SUBJECT: TECHNICAL REVIEW OF TANKS 5 AND 6 SPECIAL ANALYSIS AT
F-TANK FARM FACILITY, SAVANNAH RIVER SITE (PROJECT NO.
PROJ0734)

Technical Review of Special Analysis for Tanks 5 and 6

Date: September 27, 2013

Figure 1. 100 m Sector Doses Over 100,000 Year Simulation Period Using Reference Case Parameters. Image Credit: SRR-CWDA-2012-00106, Revision 1, Figure 6.3-5.

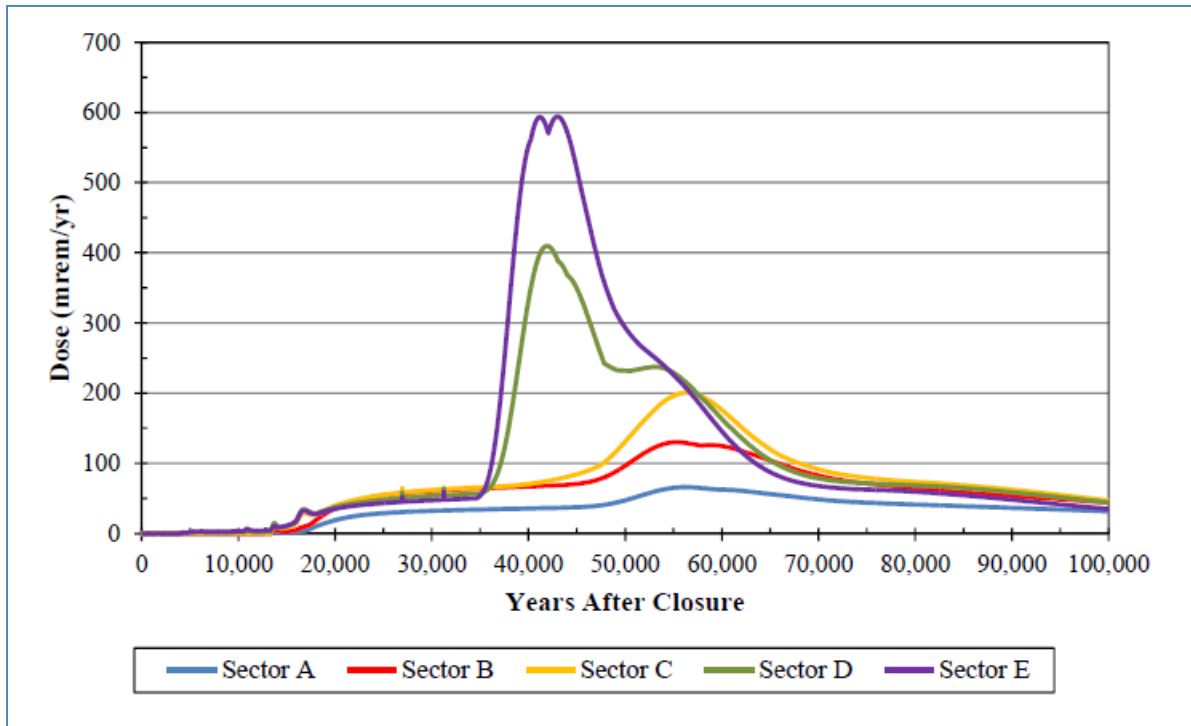
The peak 100 m Sector E dose of almost 600 mrem/yr (6 mSv/yr) (see Figure 1) is higher than the F-Tank Farm Performance Assessment, Revision 1, and Tanks 18 and 19 Special Analysis peak doses, due to the contribution of Nb-93m dose from Type I Tanks to the overall peak dose (see Figure 2). The Pu-239 dose that represents the majority of the overall peak dose is associated with Tank 18. Although the peak dose is associated with Sector E, Tank 5 and Tank 6 contribute most to the Sector D contributions. Figures 3 and 4 below show the contributions

Figure 3. All Tank and Tank 5 Only Sector D (100 m) Dose Over a 100,000 Year Simulation Period Using Reference Case Parameters. Image Credit: SRR-CWDA-2012-00106, Revision 1, Figure 6.3-12.

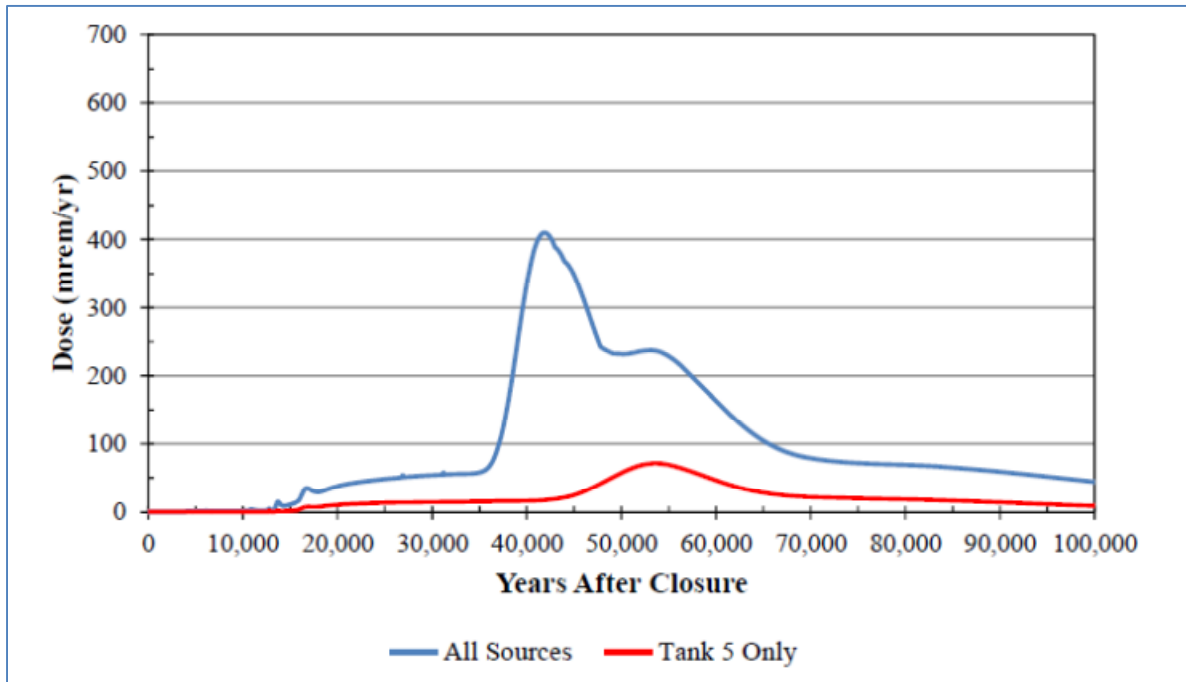
of Tank 5 and Tank 6, respectively, to the overall dose in Sector D. The peak dose in Sector D that occurs around 40,000 years is associated with Pu-239 from Tank 18. The most significant contributions from Tank 5 and Tank 6 to the Sector D dose occur later in time, between 50,000 and 60,000 years, and are attributable to Nb-93m and Pu-239 (see Figures 5 and 6).
